Reference: 200400681  
NRCS

Enclosed for your review and comment are revised drawings dated February 14, 2008, and the proposed permit modification submitted to the U.S. Army Corps of Engineers (Corps) by the NRCS concerning the above referenced permit application located in wetlands adjacent to the Willapa River, one mile downstream of the City of South Bend in Pacific County, Washington.

**Subject:** Willapa Estuary WRP Project  
Proposed Project Modification  
Dike Removal and Restoration of Tidal Channels

**WILLAPA ESTUARY RESTORATION PROJECT**  
**2008 REQUESTED MODIFICATION**  
**PROJECT LAYOUT**

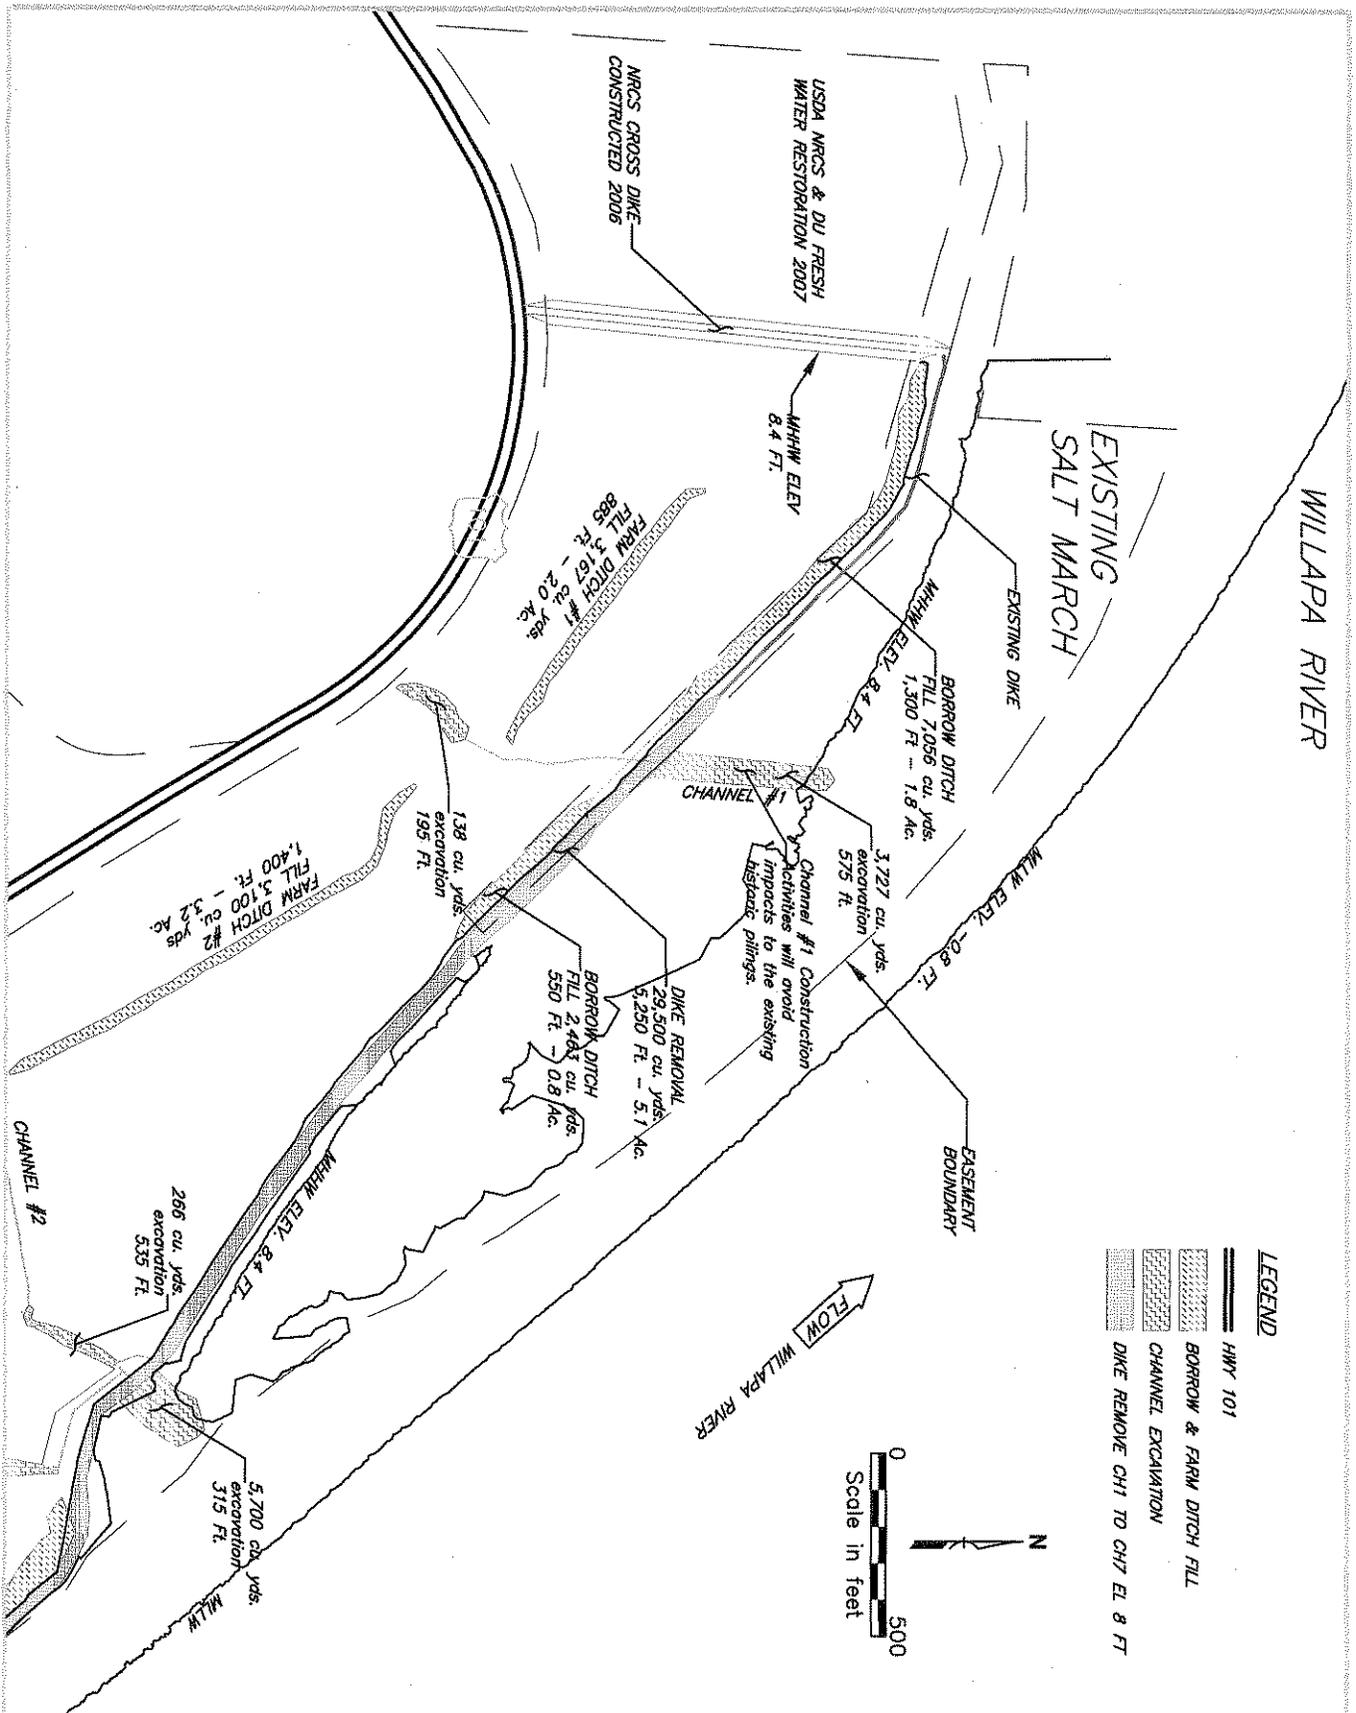
The proposed revision consists of removing up to 5,450 lineal feet of existing levee, and excavating an estimated 30,700 cubic yards of levee, mudflat channel and tidal channel material. Additional information for the proposed permit modification is attached to this letter.

- Approximately 5,450 lineal feet of dike (existing wetland fill) will be removed.
- Dike removal will convert 5.3 acres of existing filled land to an estuarine wetland.
- Available fill material from dike removal will be approximately 30,700 cu. yds.
- Maximum depth of excavation on the 5.3 acres of existing filled land (dike) is 8.5 feet and will lower the existing ground elevation to 8.0 feet NAVD88.

- Approximately 2.8 acres of salt marsh on the river side of the existing dike will be disturbed to construct the four tidal inlets.
- Approximately 925 lineal feet of tidal channels will be excavated on the river side of the existing dike to construct the tidal channel inlets to channel numbers 1, 2, 7, and 8.

**WILLAPA ESTUARY RESTORATION PROJECT**  
**2008 REQUESTED MODIFICATION**  
**DIKE REMOVAL & BARROW DITCH FILL**

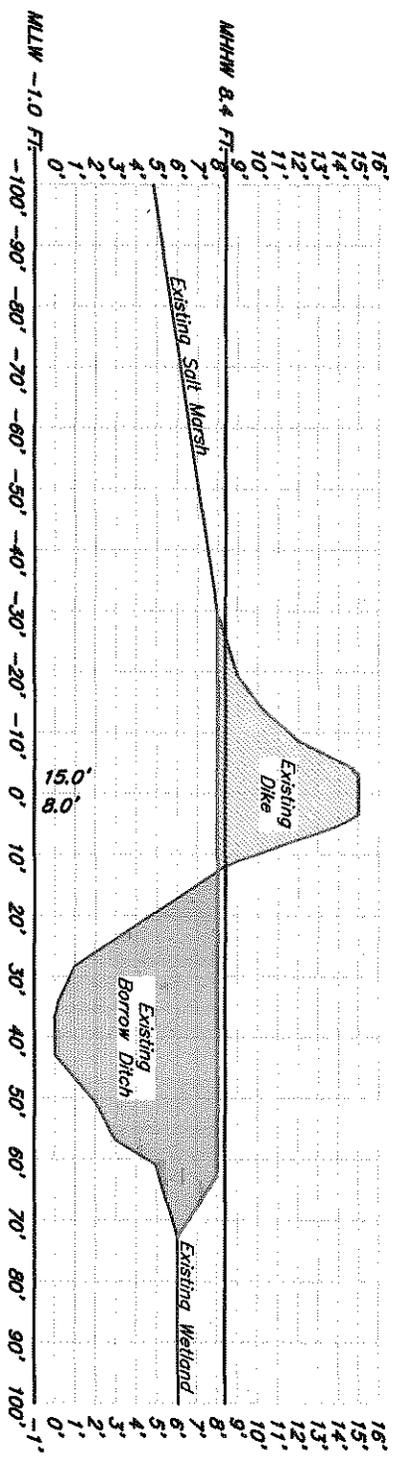
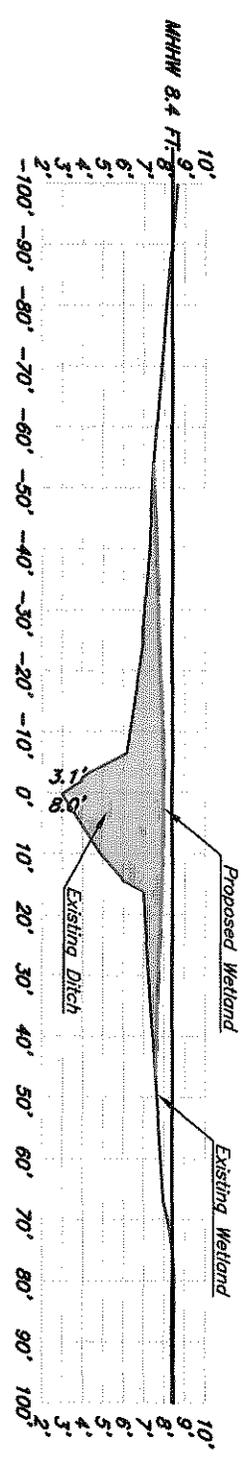
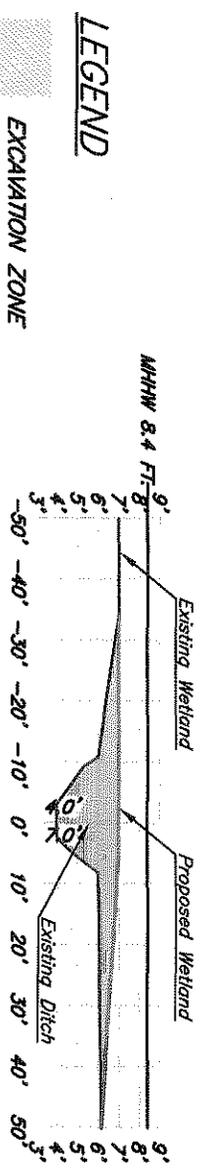
- Excavated material from the existing dike will be discharged into the existing dike borrow ditch and existing field drainage ditches number 1 and number 2.

- Up to 24,430 cubic yards of material from the existing dike will be discharged into 5,700 lineal feet of the existing borrow ditch. Total borrow ditch fill (received from all project elements) will cover an area of up to 8.1 acres to a maximum depth of up to 8.7 feet (minimum existing ditch bottom elevation of -0.7 feet NAVD88 to maximum fill elevation of 8.0 feet NAVD88).

- Up to 3,170 cubic yards of material from the existing dike will be discharged into the existing field drainage ditch 1, and will cover an area of up to 2.0 acres to a maximum depth of up to 5.4 feet (minimum existing ditch bottom elevation of 2.6 feet NAVD88 to a maximum fill elevation of 8.0 feet NAVD88).

- Up to 3,100 cubic yards of material from the existing dike will be discharged into the existing field drainage ditch 2, and will cover an area of up to 3.2 acres to a maximum depth of up to 5.0 feet (minimum existing ditch bottom elevation of 2.0 feet NAVD88 to a maximum fill elevation of 7.0 feet NAVD88).

**WILLAPA ESTURARY RESTORATION PROJECT**  
**2008 REQUESTED MODIFICATION**  
**CHANNEL EXCAV. & DIKE REMOVAL**

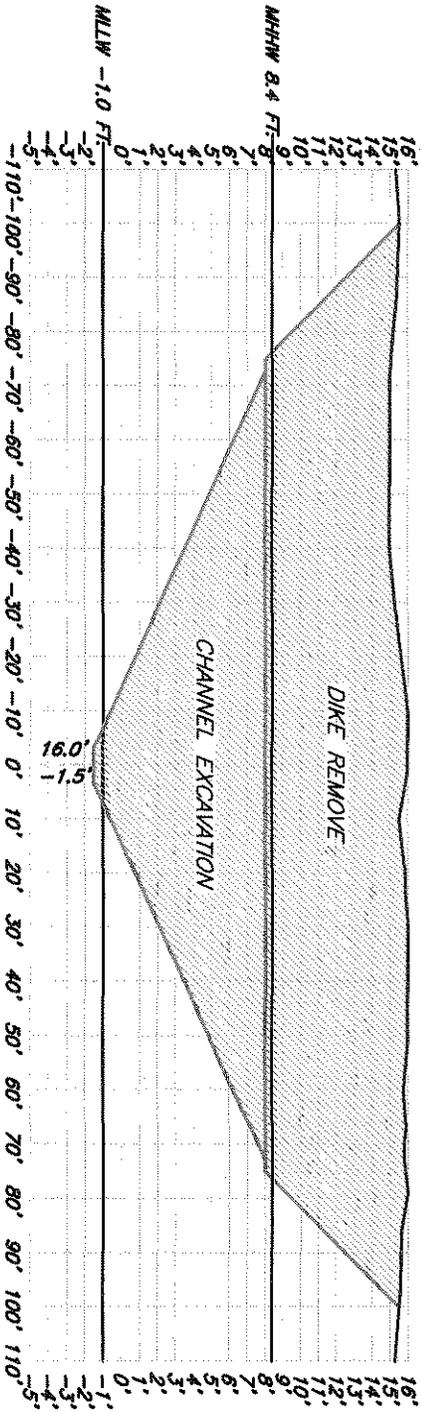
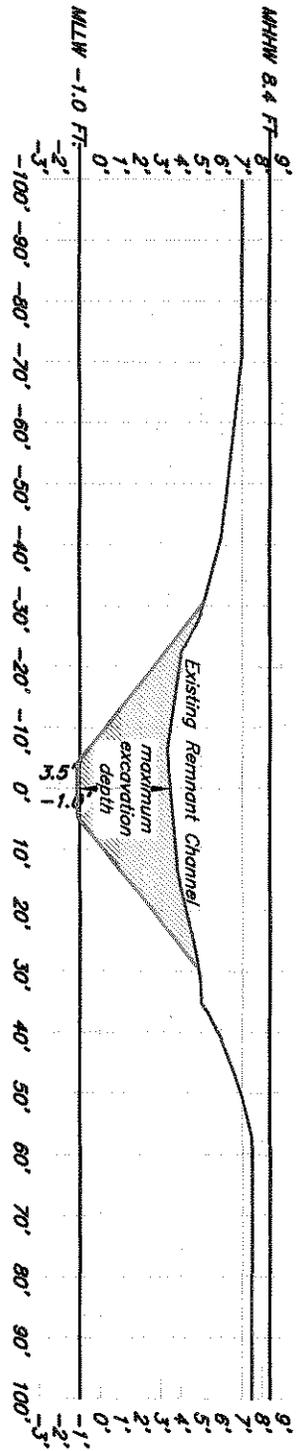
- Approximately 315 ft of tidal channel numbers 1, 2, 7 and 8 will be restored after the existing dike fill is removed to connect the tidal inlets to the remnant tidal channels.

- Available fill material from excavation of tidal channels at the location of the existing dike fill will be approximately 5247 cu. yds.
  - Approximately 75 linear feet will be excavated for tidal channel 1 up to a maximum depth of 5.0 feet (bottom elevation of 3.0 feet NAVD88), up to 407 cubic yards of material will be discharged into 5,700 lineal feet of the existing borrow ditch. Total borrow ditch fill (received from all project elements) will cover an area of up to 8.1 acres to a maximum depth of up to 8.7 feet (minimum existing ditch bottom elevation of -0.7 feet NAVD88 to maximum fill elevation of 8.0 feet NAVD88).

- Approximately 75 linear feet will be excavated for tidal channel 2 up to a maximum depth of 11.5 feet (bottom elevation of -3.5 feet NAVD88), up to 2,350 cubic yards of material will be discharged into 5,700 lineal feet of the existing borrow ditch. Total borrow ditch fill (received from all project elements) will cover an area of up to 8.1 acres to a maximum depth of up to 8.7 feet (minimum existing ditch bottom elevation of -0.7 feet NAVD88 to maximum fill elevation of 8.0 feet NAVD88).

- Approximately 80 linear feet will be excavated for tidal channel 7 up to a maximum depth of 8.5 feet (bottom elevation of -0.5 feet NAVD88), up to 1,190 cubic yards of material will be discharged into 5,700 lineal feet of the existing borrow ditch. Total borrow ditch fill (received from all project elements) will cover an area of up to 8.1 acres to a maximum depth of up to 8.7 feet (minimum existing ditch bottom elevation of -0.7 feet NAVD88 to maximum fill elevation of 8.0 feet NAVD88).

- Approximately 85 linear feet will be excavated for tidal channel 8 up to a maximum depth of 9.5 feet (bottom elevation of -1.5 feet NAVD88), up to 1300 cubic yards of material will be discharged into 5,700 lineal feet of the existing borrow ditch. Total borrow ditch fill (received from all project elements) will cover an area of up to 8.1 acres to a maximum depth of up to 8.7 feet (minimum existing ditch bottom elevation of -0.7 feet NAVD88 to maximum fill elevation of 8.0 feet NAVD88).
